## **REMARKS**

This amendment is in response to the Official Action mailed on June 22, 2004. Claims 1 to 5 and 7 to 10 have been amended. Claim 6 has been canceled. Claims 11 to 22 are new. Thus, claims 1-5 and 7-22 are currently pending.

FIG. 1

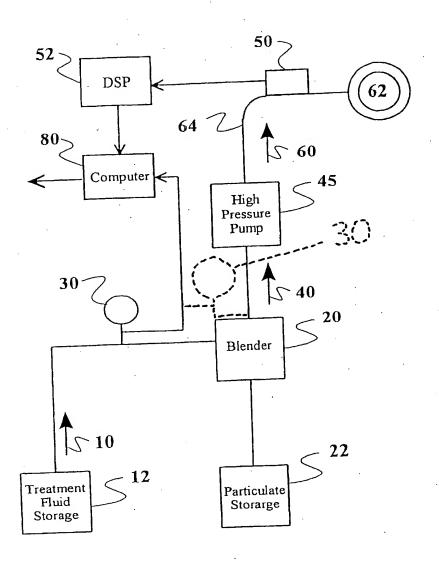
In the Official Action, the Examiner has objected to the drawings under 37 C.F.R. 1.83(a), as not showing every feature of the invention specified in the claims. Specifically, the Examiner objects to the "placement of a flow meter at a point in the flow stream after particulates are added to the fluid stream" limitation in claim 4. In response, Figure 1 has been amended to show the flow meter 30 alternatively connected to the discharge from blender 20. Support for the amendment can be found in the description at page 6, lines 18 to 21. Similarly, the paragraph on page 6, line 18 has been amended to more particularly describe the amendment to Figure 1. This amendment does not constitute new matter, but rather more clearly points out subject matter which was clearly supported in the application as originally filed.

Please replace the sheet including Figure 1 with the replacement sheet including Figure 1 submitted herewith.
